#### **CABINET MEMBER FOR ENVIRONMENT – 18 JUNE**

# FARINGDON: SOUTHAMPTON STREET & BERNERS WAY PROPOSED SHARED USE FOOTPATH / CYCLETRACKS

#### **Report by Interim Director of Community Operations**

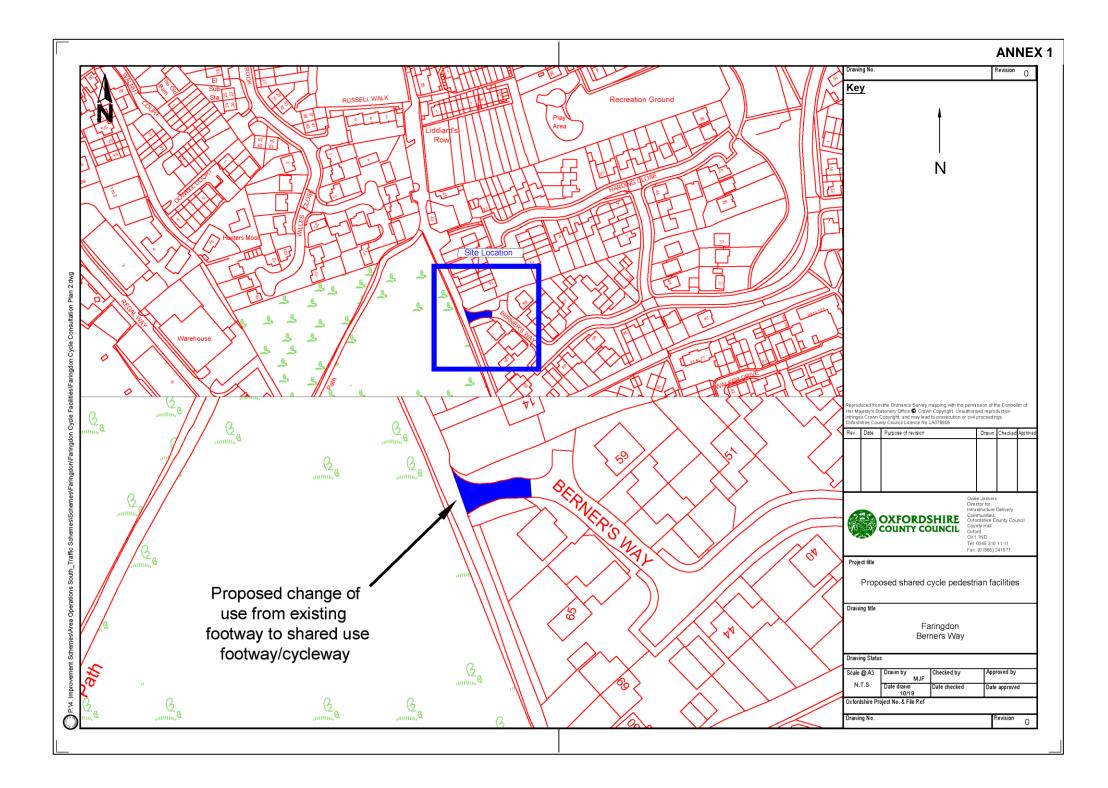
(4) Local Resident, (Faringdon)	Object (Southampton Street) – The plans for this proposal only show the start at Southampton Street and the entrance to Berners Way which is deceiving because Southampton Street crosses a road (Bennett Road/The Lees) and continues along a narrow road until it meets Berners Way.  Southampton Street is usually always full of parked cars on both sides which means the very narrow pavement cannot be currently used by pedestrians and have to walk in the single-track road as it is. This also links to 'The Hobble' which is a pedestrian only route - turning Southampton Street into a bike route will only encourage people to cycle up this also. The safety of walkers must be considered in this plan which is currently ignored.  This scheme is a pointless waste of money and it will not encourage any more people to use their bikes. Maybe a cycle route on the main Park Road would be a far better suggestion?

(5) Local Resident, (Faringdon)	Object (Berners Way & Southampton Street) – This is not a necessary change and so not a good use of limited OCC funds. It is no hardship for cyclists to get off and walk a few metres.  The paths are widely used by children, old people and dog walkers, as a route to the medical centre. Shared use pedestrian / cycle paths of the proposed width are inherently dangerous to these populations due to the aggressive riding of some cyclists and the lack of any effective policing.

Signs reminding cyclists to dismount on the sections in question would be a better solution.
(6) Local Group, (CTC, Oxford)	Support (Berners Way & Southampton Street) – This will improve permiability for cycling. From google street view (2008), please ensure:  1. Vegetation is kept trimmed back.  2. The posts have visibility bands on to help visually impaired people, and so cycle users can see the posts in the dark.  While making sections like this shared use are useful, there is often poor signage/lining to show where the shared use ends and you can no longer cycle on the footway. What do you propose to show the end if the cyclable sections of footway to prevent cycle users continuing to cycle illegally on the footway, unaware the usage has changed?

- 10. In response to the first point the southern end of Southampton Street is wide enough for pedestrians to share the carriageway with cyclists when necessary, the width of the footpath running up to Folly View will be maximised by siding out and cutting back the hedgerow and shared use signage provided along the routes to highlight the presence of both types of user.

- 11. In response to the second point, the scheme is being funded by Faringdon Town Council using Section 106 monies from the Folly View housing estate allocated to the specific purpose of providing an improved and safer cycle link between the estate and the town centre. It is hoped that the scheme will encourage more people to cycle this short distance.

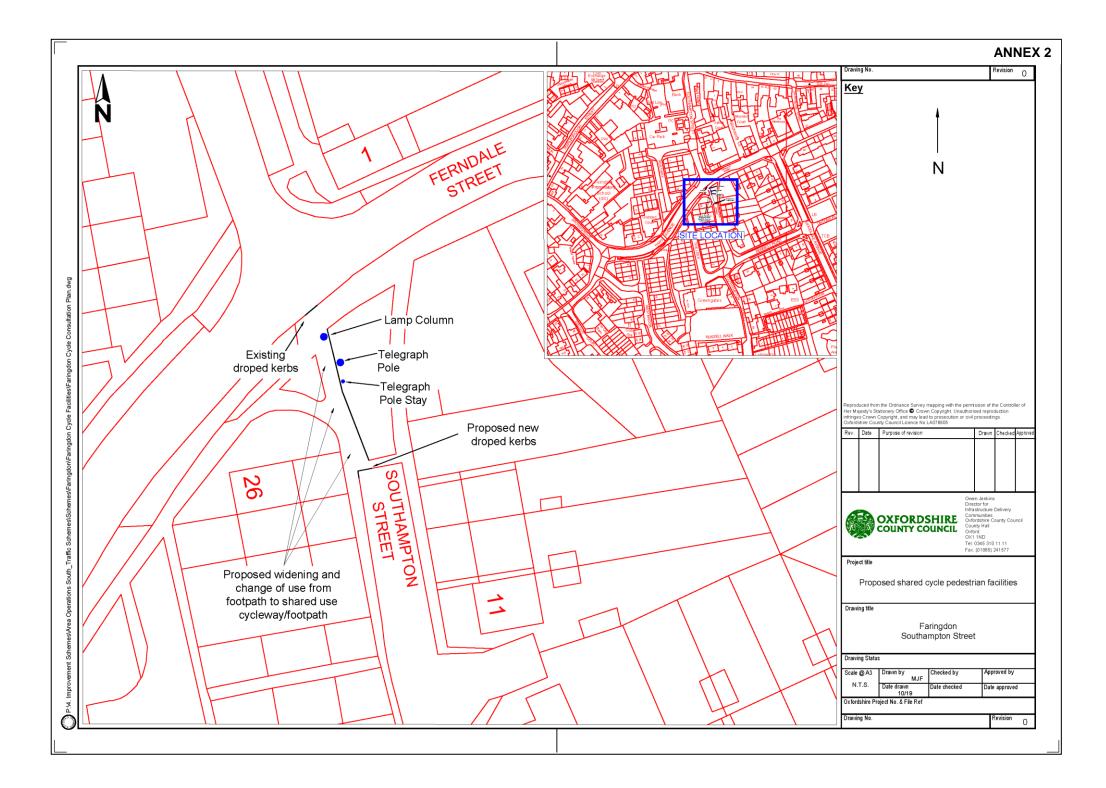
(9) Local Resident, (Faringdon)	<b>Support</b> (Berners Way) – I support the idea of continuing a cycle way to join Berners Way to the existing track. However, I hope that thought is given to preventing motorcycles from using the route. A few years ago, a young person died as a result of riding a motorcycle on the track and then colliding with a wall.
